# 461 CHAPEL ROAD

BANKSTOWN 2200

DESIGN REVIEW REPORT

07 / 04 / 2025

**ITEM 03.04 - MULTIPURPOSE SPACES**

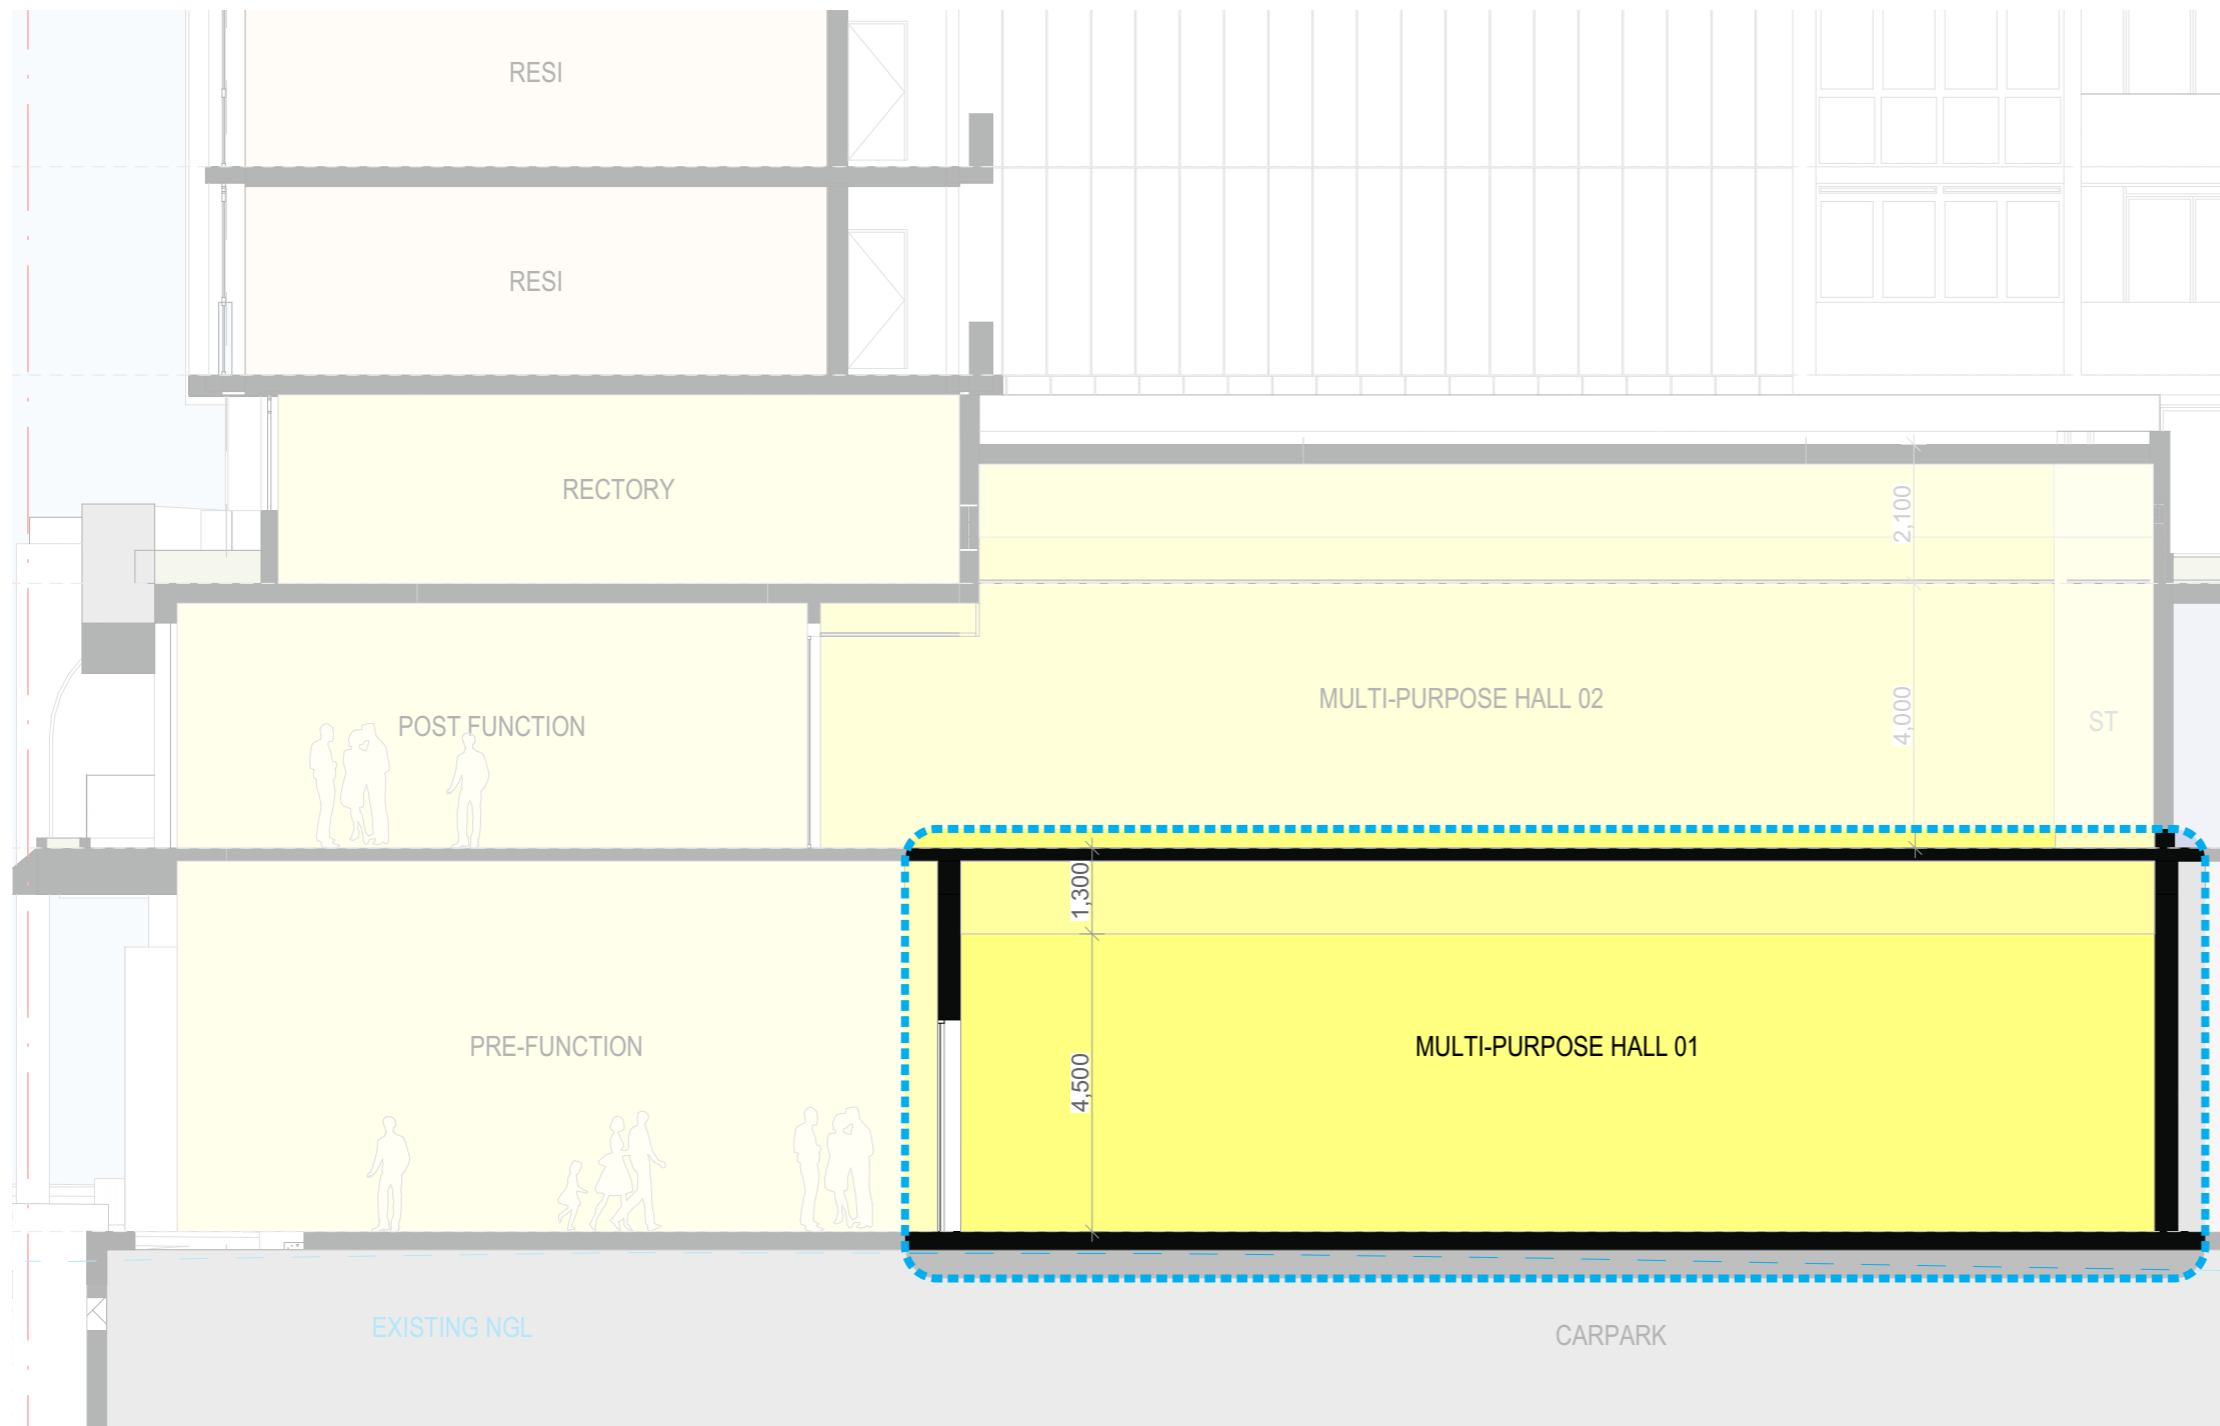
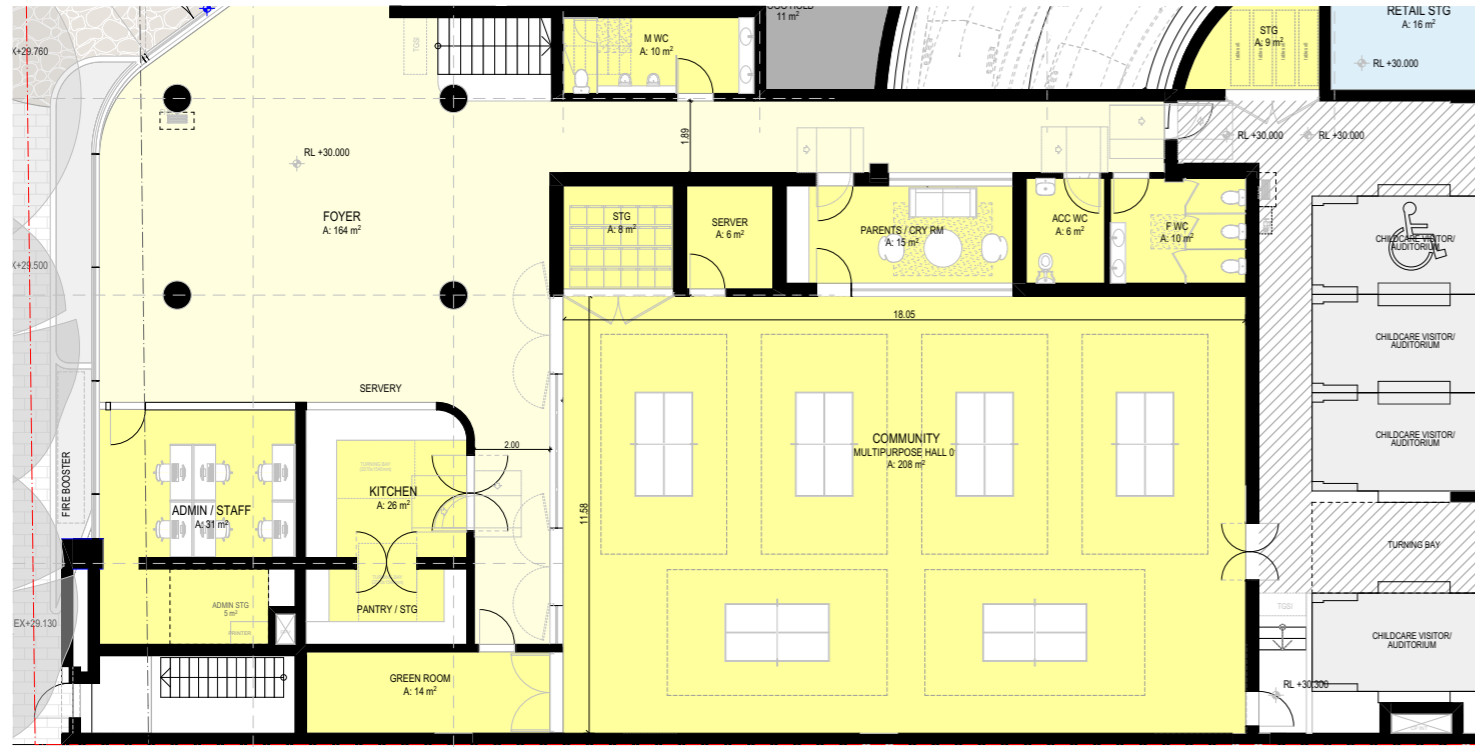
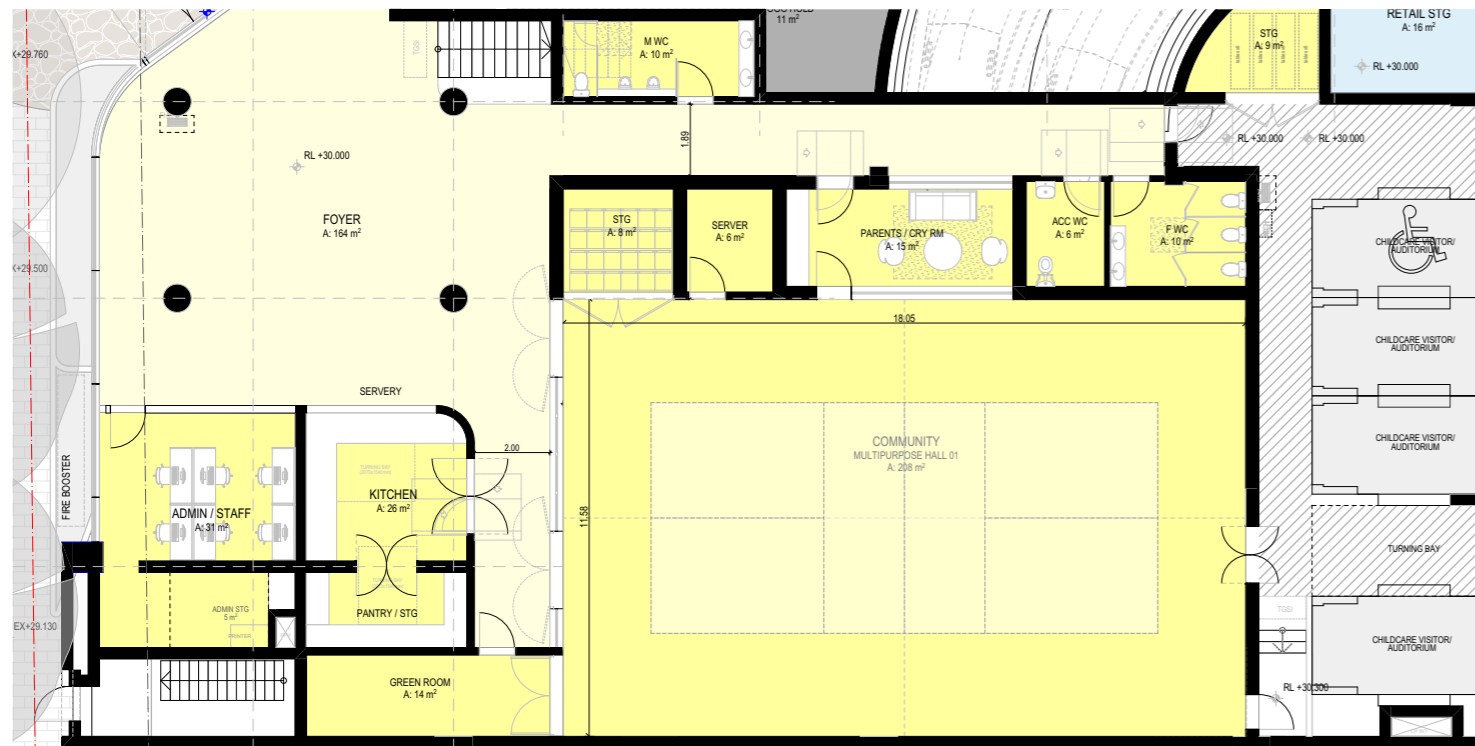
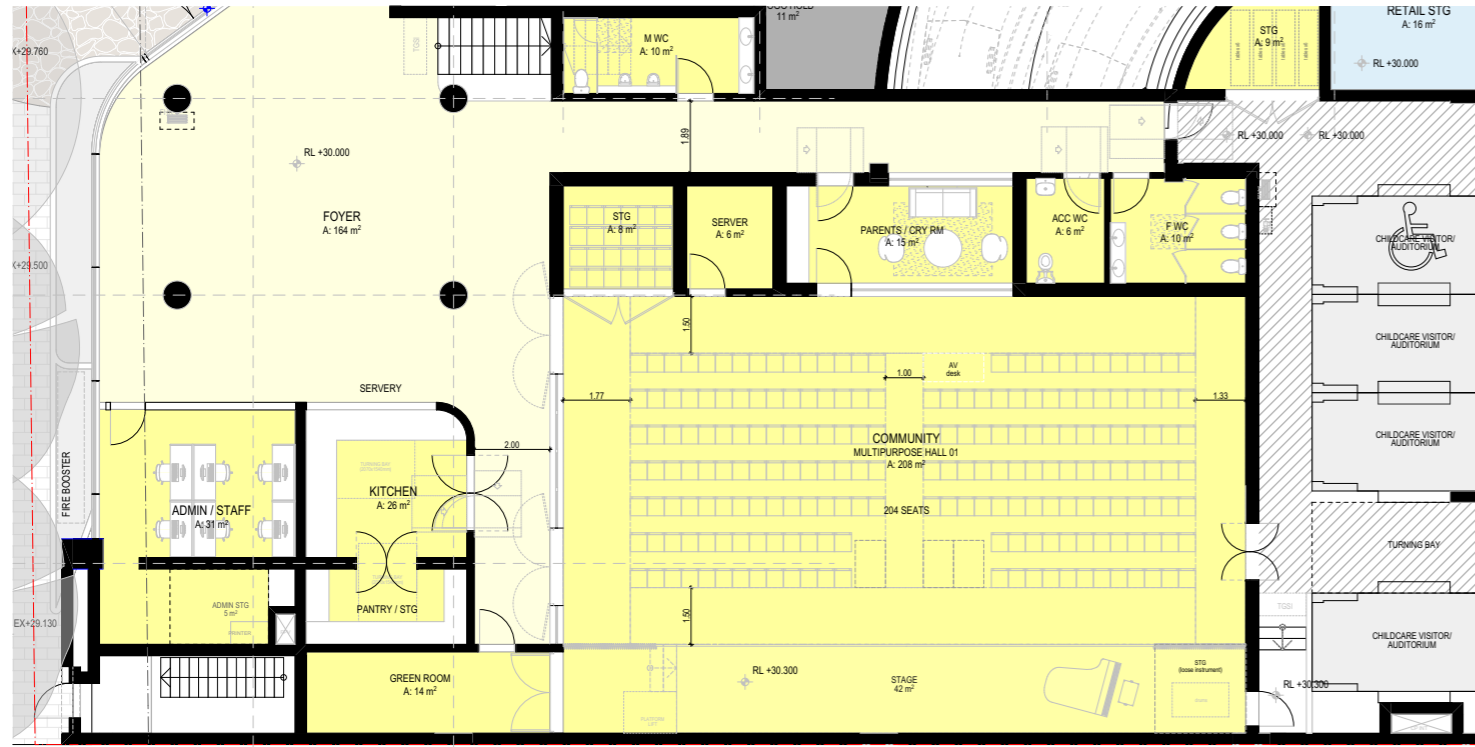
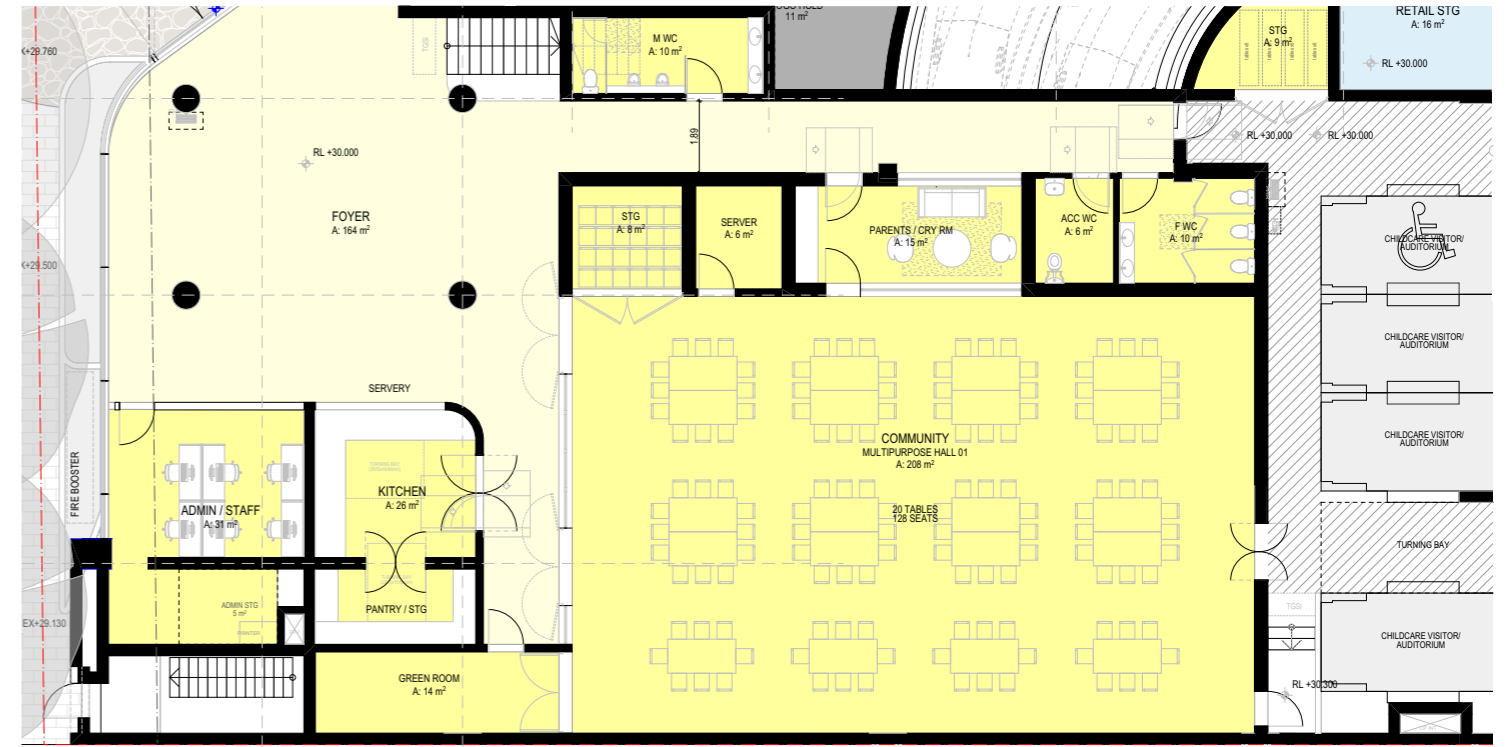
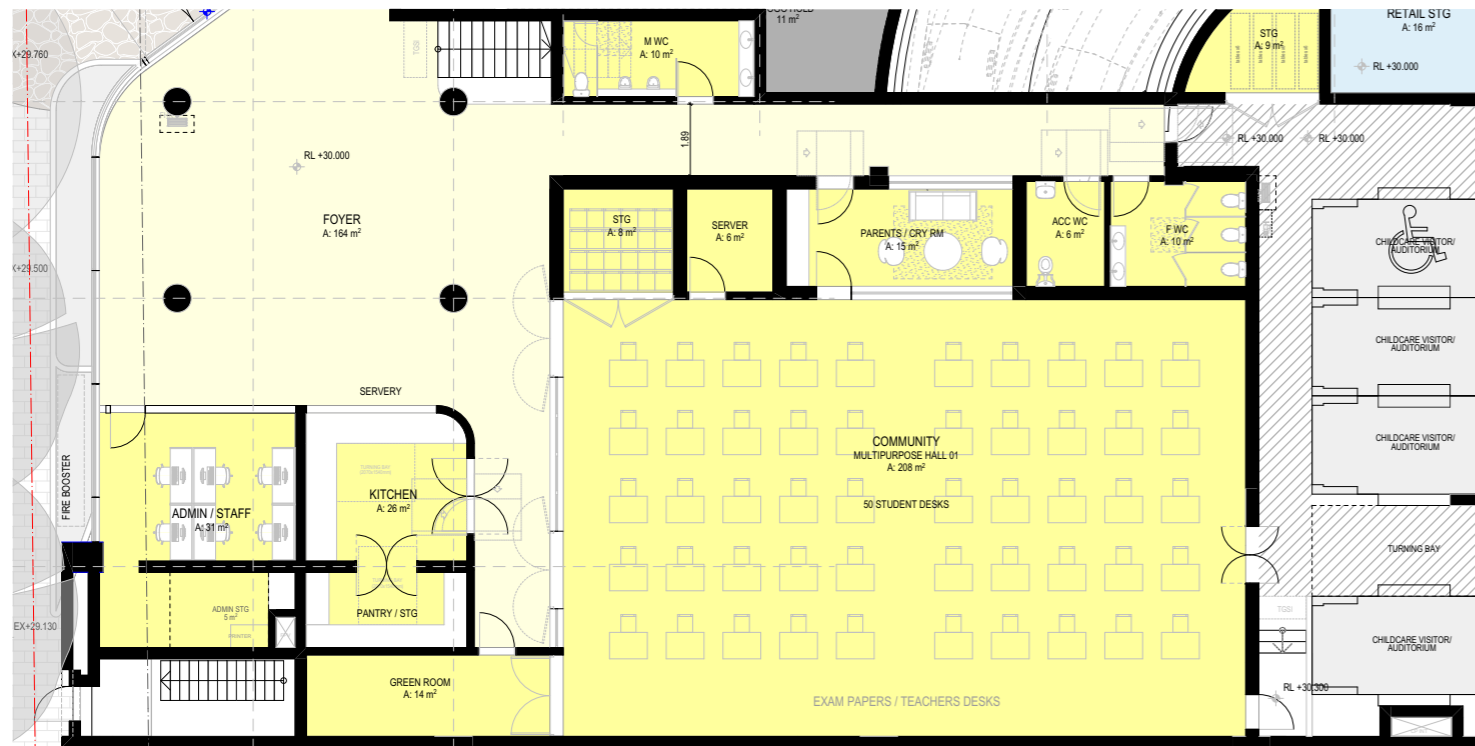
Providing two distinct multipurpose spaces offers great flexibility and opportunities to activate the project for community benefit.

a. Confirm the dimensions of each space and identify what functions can be accommodated. Seek opportunities to support community programs and business

b. Clarify hours of use and identify potential impacts on adjacent uses e.g. residential, childcare, parking and church functions.

- The dimensions of the ground floor community facility are 18.05m x 11.58m
- The dimensions of the Level 1 community facility are 18.65m x 14.58m

a. The ground floor community facility will accommodate various activities including a variety of indoor recreation uses that support the physical wellbeing of the community, such as dancing, gymnastics, pickleball, table tennis and more, whilst also being appropriate to support other community wellbeing programs, such as Alcoholics Anonymous.

b. An Operational Management Plan has been prepared for the Community facility and outlines how impacts between adjacent uses will be managed. This is detailed within Section 4.6.2 of the EIS.
